Draft Submittal
(Pink Paper)

Reactor Operator Written Exam

ST. LUCIE MARCH/APRIL 2006-301 EXAM
05000335/2006301 AND 05000389/2006301
MARCH 20 - 29, 2006 AND APRIL 6, 2006

FIGURE 9

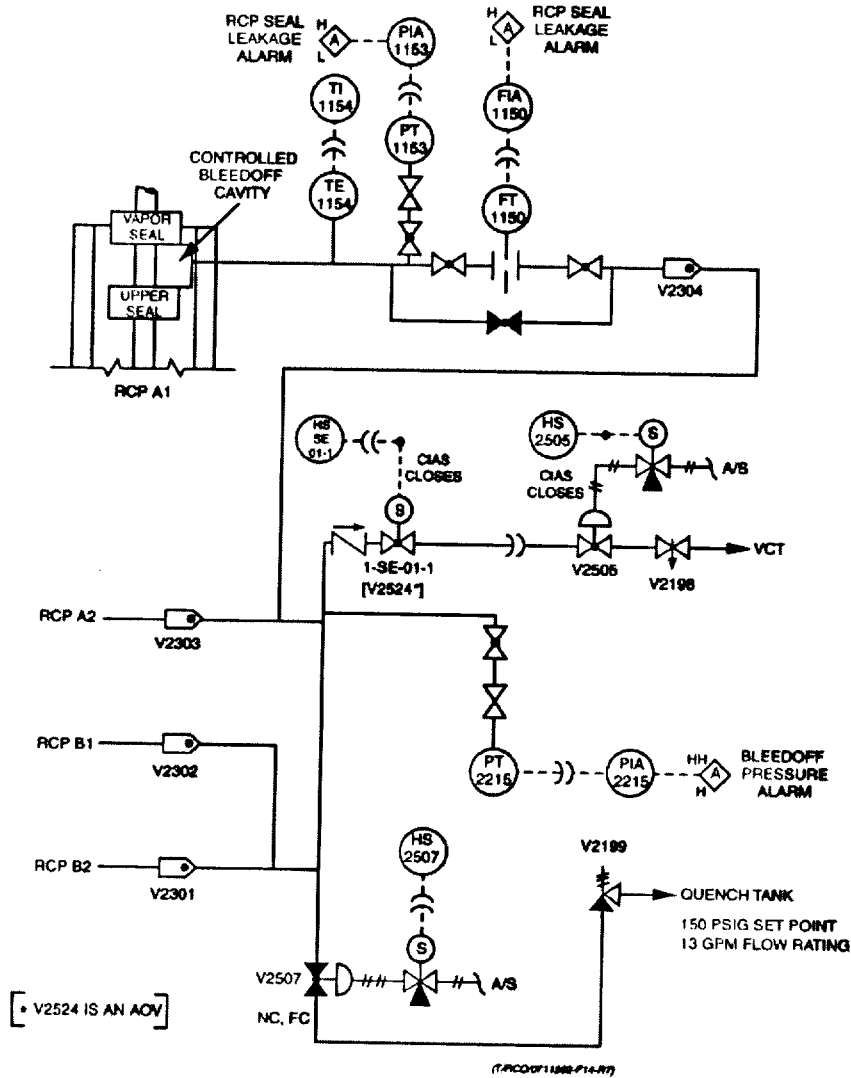
Comments: From 0711202, RCP System Description, Figure 9
